METROPOLITAN GOVERNMENT OF NASHVILLE AND DAVIDSON COUNTY

STAFF RECOMMENDATION
1627-1629 Shelby Avenue
January 15, 2020

Application: Demolition—Outbuilding; New Construction—Outbuilding
District: Lockeland Springs-East End Neighborhood Conservation Zoning Overlay
Council District: 06
Base Zoning: R6, Neighborhood Landmark Overlay
Map and Parcel Number: 08314030000
Applicant: Lynn Taylor, Taylor Made Plans
Project Lead: Melissa Baldock, melissa.baldock@nashville.gov

Figure 4. The outbuilding that is proposed to be demolished.

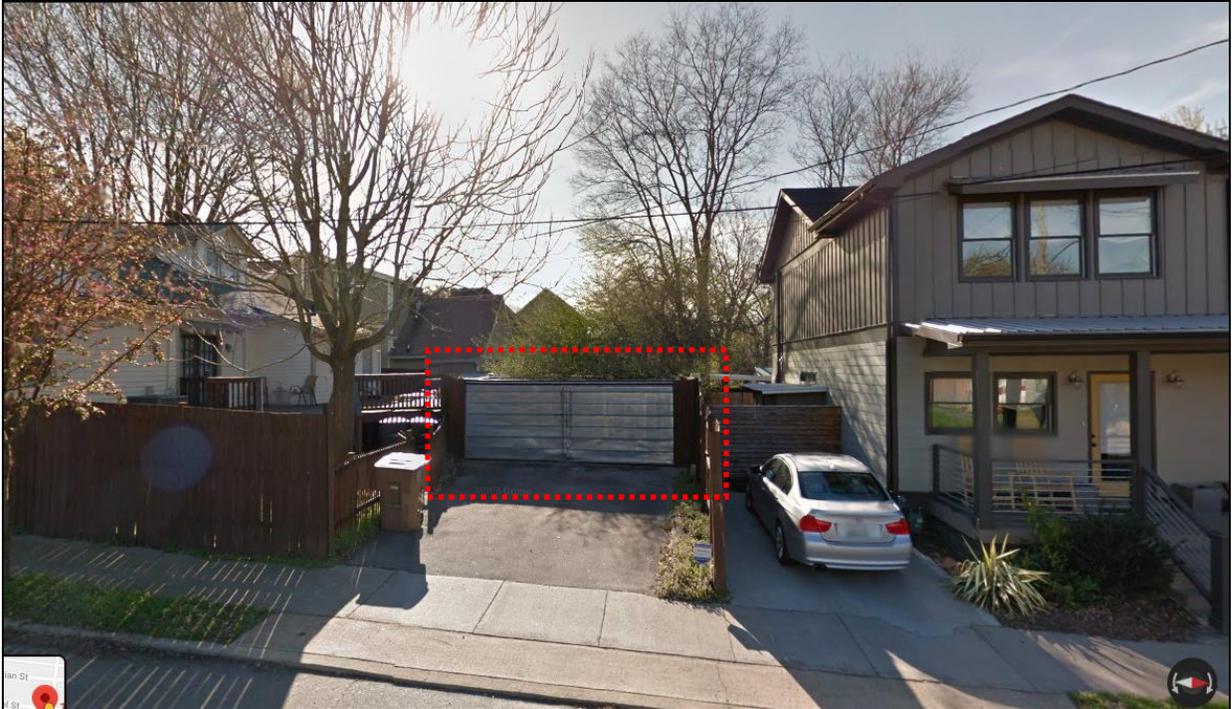
Demolition: The date of construction for the existing outbuilding is unknown, but it does not seem to be the same structure that appears on the 1957 Sanborn map (Figures 4,5,6). Staff finds that the outbuilding's date of construction, materials, roof form, and overall design do not contribute to the historic character of the Lockeland Springs-East End Neighborhood Conservation Zoning Overlay.

Staff finds that the proposed demolition of the outbuilding meets Section III.B.2. of the design guidelines for appropriate demolition.

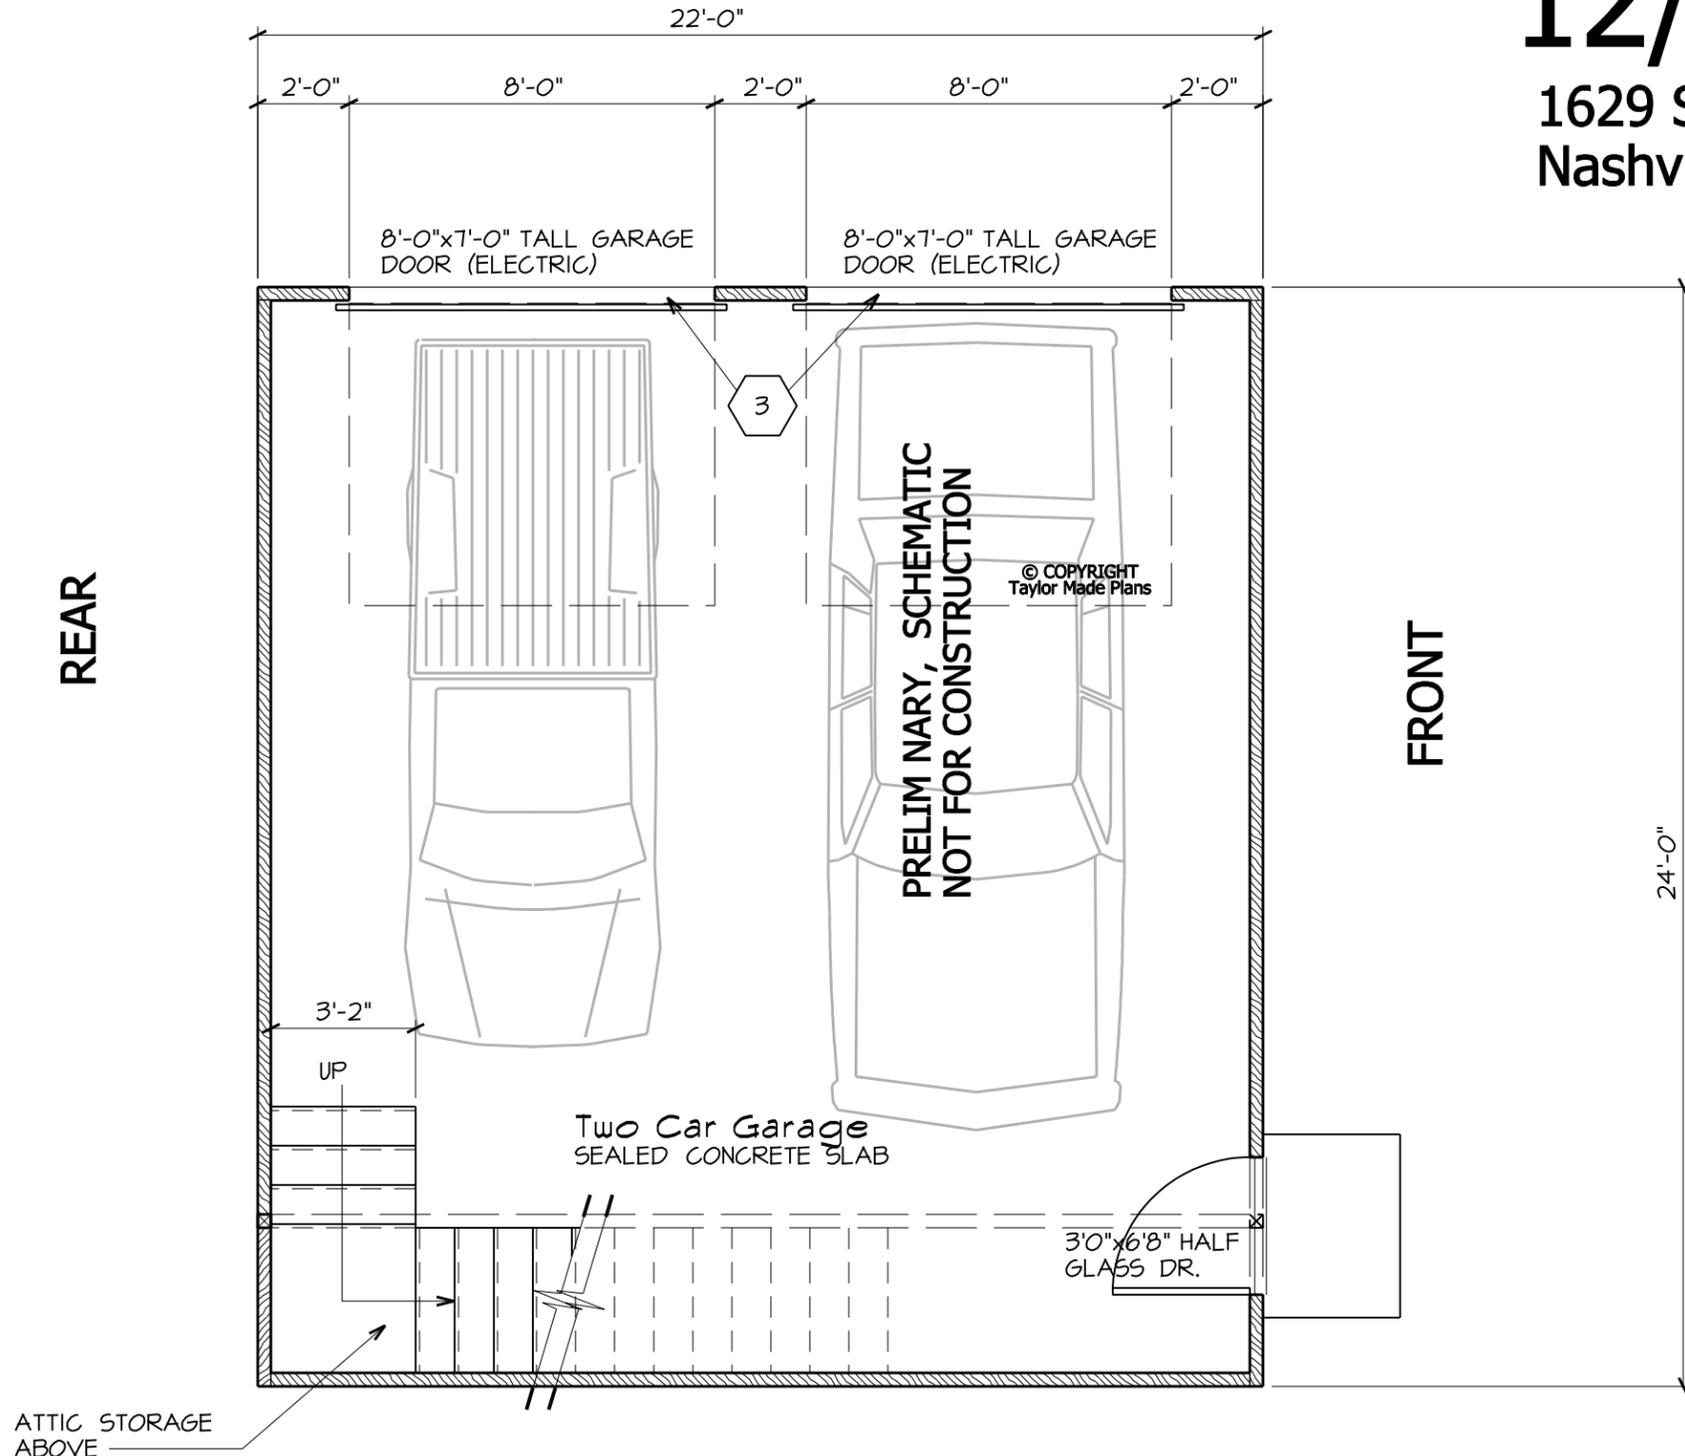
*The proposed garage meets the base zoning setbacks but does not meet the design guidelines requirement that there be at least twenty feet (20’) between the back of the house/primary structure and the outbuilding. The applicant is proposing that there be just fourteen feet (14’) of distance between the back of the house and the new outbuilding.

Staff finds that the reduced space between the two structures is appropriate, in this instance, because the lot is unusually shallow at just one hundred feet (100’) deep. This is fifty feet (50’) shallower than the typical lot on the south side of Shelby Avenue. 1627 Shelby’s lot is particularly shallow because the back fifty feet (50’) of the lot was subdivided off by deed in the 1960s to create another lot facing South 17th Street. Because of the shallowness of the lot, it is difficult to have twenty feet (20’) of space between the two structures, while still meeting the rear setback and while allowing for a two-car garage. The Commission has regularly approved distances as little as ten feet (10’) when lots are particularly shallow like this one.

Staff finds that the proposed location and setbacks of the garage meet Section II.B.8. of the design guidelines.
